Re: United Heckathorn Superfund Site, Richmond, California

This technical memorandum presents a review of the Draft Focused Feasibility Study (Draft FFS) recently issued by the U.S. Environmental Protection Agency (USEPA) for cleanup measures at the Former United Heckathorn site in Richmond, California (Site; Figure 1). The Draft FFS presents the development and analysis of remedial alternatives for marine sediments that continue to be impacted by various contaminants of concern in the Lauritzen Channel (referred to herein as "the Channel"), following an initial cleanup attempt in 1996 and 1997.

Figure 1
Site Location Map
Engineering Review of Draft FFS
Former United Heckathorn Site, Richmond, California

Figure 9
Conceptual Confined Disposal Facility (CDF) Area
Engineering Review of Draft FFS
Former United Heckathorn Site, Richmond, California

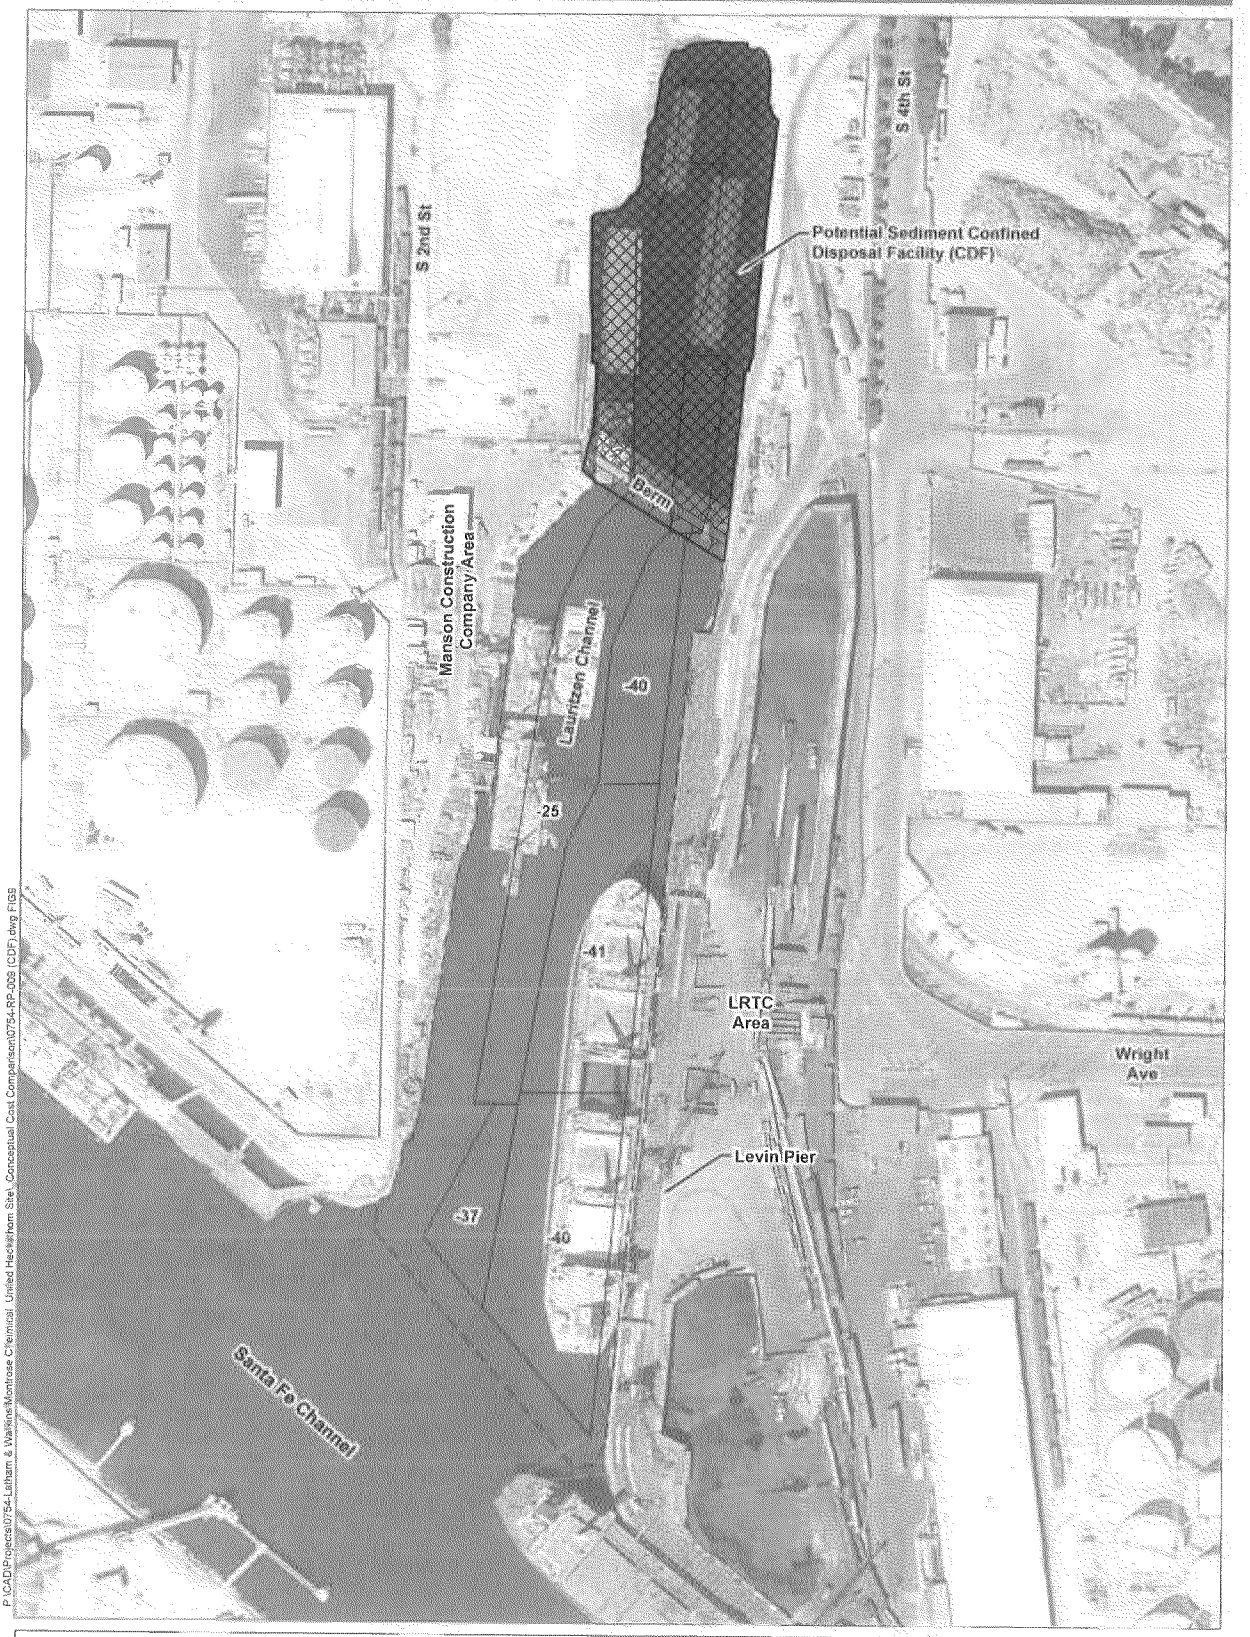
A conceptual CDF at the Site, depicted on Figure 9, would be located in the Northern Head of the Lauritzen Channel. Sediment could be placed behind a retaining berm built across the channel, north of the Levin Pier, using sand/gravel fill and armoring rock on the face. This conceptual geometry would result in the filling of approximately 2 acres. Approximately 40,000 cy of sediment could be placed behind the berm to a top elevation of +1 feet MLLW, while the remaining dredged material would be disposed off-site. Another 15,000 cy of sediment would be confined in placed beneath the CDF. By capping the area with clean fill to match surrounding grades, usable land area could be created.

The CDF depicted on Figure 9 would provide cost savings by avoiding transportation and disposal of sediments at a distant or out-of-state upland facility. In addition, the CDF permanently confines existing sediments within its footprint, further reducing the volume of sediment that might require dredging, transportation, and disposal.
